ALERT SERVICE BULLETIN

212-19-161

MODEL AFFECTED: 212

SUBJECT: REDUCTION GEARBOX OIL TUBE ASSEMBLY
P/N 212-061-533-001, INSPECTION OF.

Figure 1. Tube assembly 212-061-533-001 location.

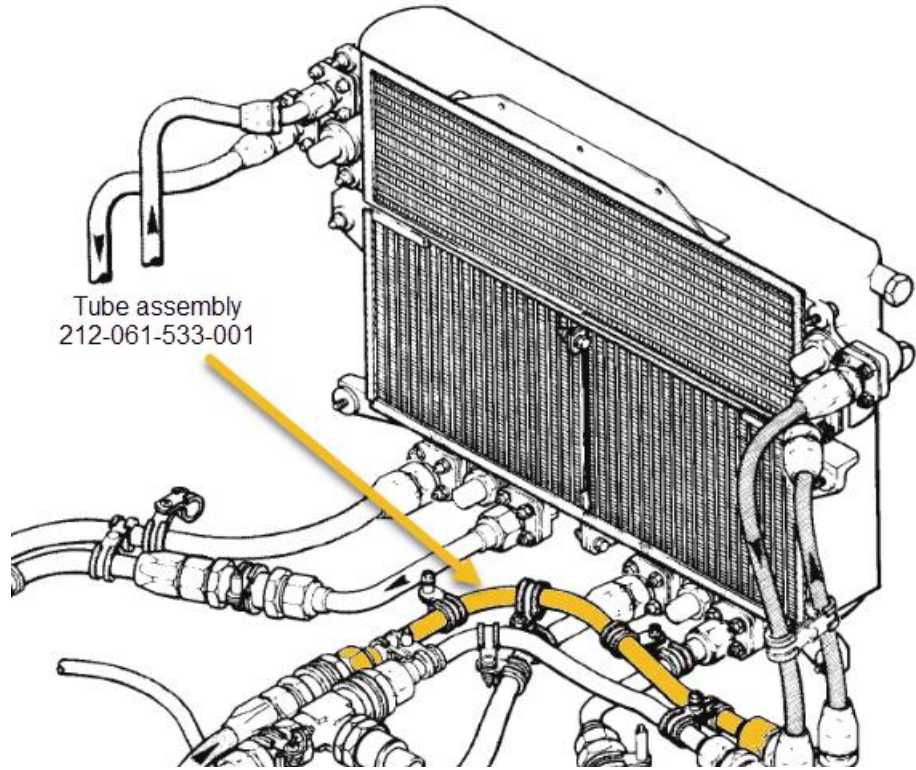
1. Prepare the helicopter for maintenance and gain access to the tube assembly 212-061-533-001 located under the oil cooler blowers in the aft engine compartment (Figure 1).

1. If not previously accomplished, prepare the helicopter for maintenance and gain access to the tube assembly 212-061-533-001 located under the oil cooler blowers in the aft engine compartment (Figure 1).
2. As required, reposition the clamping and the tube assembly to obtain proper clearance. The screw length may be reduced if required and washers NAS1149D0332J or NAS1149D0363J can be installed between the structure and the attaching clamps to obtain proper clearance.
3. If new holes are required to relocate the clamps, the holes that are no longer required must be plugged with sealant (C-308). Changing the clamp locations will require removal of the exhaust ejectors and oil cooler blowers. (BHT-412-MM Chapters 71 and 79).
4. Make an entry in the helicopter logbook and historical service records indicating findings and compliance with **PART II** of this Alert Service Bulletin.

Figure 2. Tube assembly supporting clamps and possible fouling area.

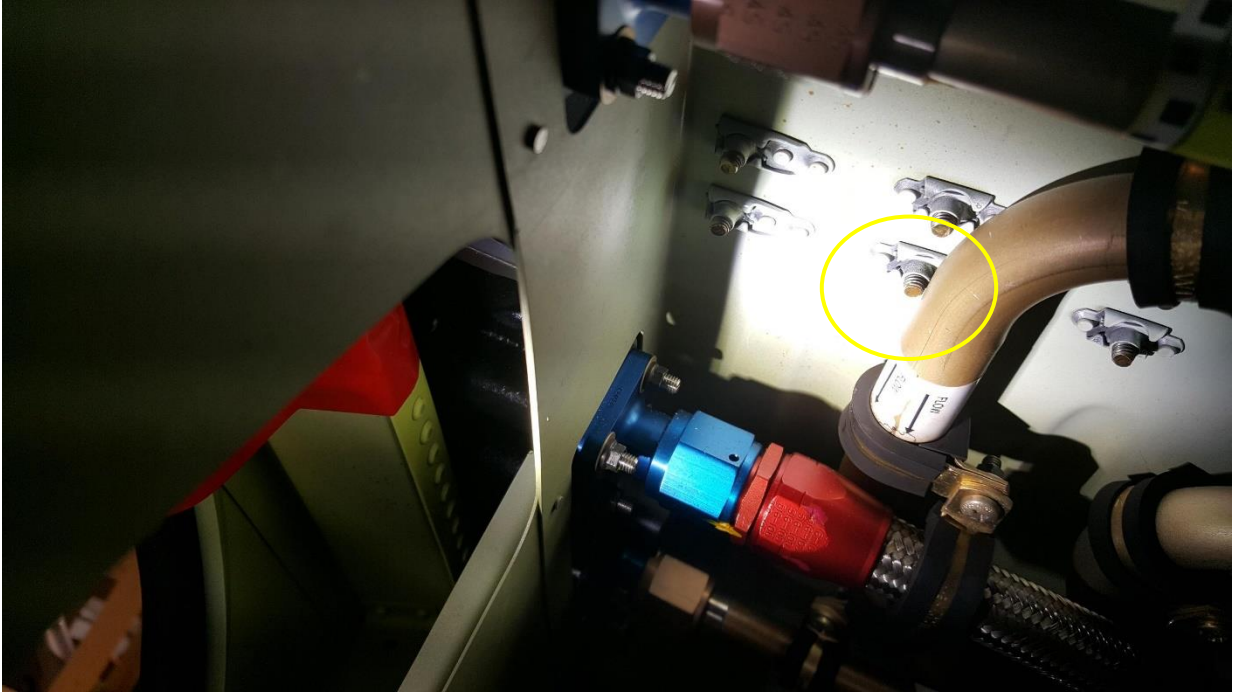
2. Using a bright light source and a feeler gauge, inspect the tube assembly for chafing damage and proper clearance between the tube assembly and the screw/nutplate (Figures 1 and 2). The maximum damage allowed is 0.003 inch (0.076 mm) and the minimum clearance required is 0.060 inch (1.52 mm).
 - a. If no chafing damage exists and the clearance meets the minimum required, no further action is required. Go to step 3.
 - b. If no chafing damage exists but the clearance is less than the minimum required, carry out **PART II** within the next 100 flight hours or 90 days whichever occurs first after the accomplishment of **PART I**.

The minimum clearance required between the tube assembly and the screw/nutplate after installation is 0.060 inch (1.52 mm).

- c. For chafing damage less than or equal to 0.003 inch (0.076 mm), blend the damage smooth using an abrasive cloth or paper (C-406) 400 grit and apply chemical film treatment (C-100) as per BHT-ALL-SPM to the repaired area. Surface finish after repair should be restored to original.

- d. Install tube assembly in accordance with **PART II** before next flight.
 - e. For chafing damage greater than 0.003 inch (0.076 mm) but less than 0.010 inch (0.254 mm), replace the tube immediately in accordance with **PART II** or accomplish step f.

- f. Blend the damage smooth using an abrasive cloth or paper (C-406) 400 grit and apply chemical film treatment (C-100) as per BHT-ALL-SPM to the repaired area. Surface finish after repair should be restored to original. Replace the tube assembly in accordance with **PART II** within the next 100 flight hours or 90 days whichever occurs first after the accomplishment of **PART I**.

- g. If chafing damage exceeds 0.010 inch (0.254 mm), replace the tube assembly and install in accordance with **PART II** before next flight.
3. Make an entry in the helicopter logbook and historical records indicating findings and compliance with **PART I** of this Alert Service Bulletin.
